RE: Case No. 2020-00040
ELECTRONIC APPLICATION OF TURKEY CREEK SOLAR, LLC FOR A
CONSTRUCTION CERTIFICATE TO CONSTRUCT AN APPROXIMATELY 50
MEGAWATT MERCHANT ELECTRIC SOLAR GENERATING FACILITY IN
GARRARD COUNTY, KENTUCKY PURSUANT TO KRS 278.700 AND 807 KAR
5:110

Review and Evaluation of Turkey Creek Solar LLC Siting Assessment Report

FINAL REPORT

July 6, 2020

Figure C-4. Visual simulation of Turkey Creek facility from home to east, approximately 570 feet away from nearest panel

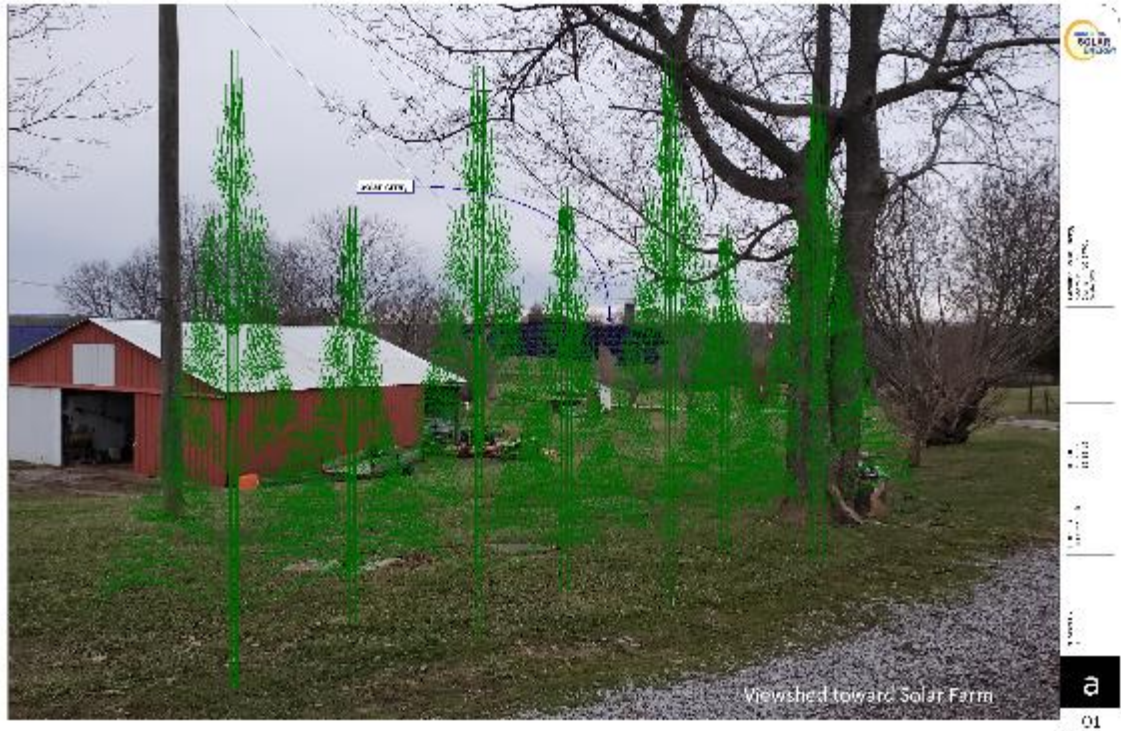
As noted earlier, BBC traveled the surrounding area during our visit to the site and took a number of photographs of the area and site from various locations. We also discussed visual impact considerations with representatives during the visit. In response to a request from BBC, Turkey

Creek provided visual simulations of the proposed facility from key observation points at two neighboring properties.⁹ Those renderings are copied below.
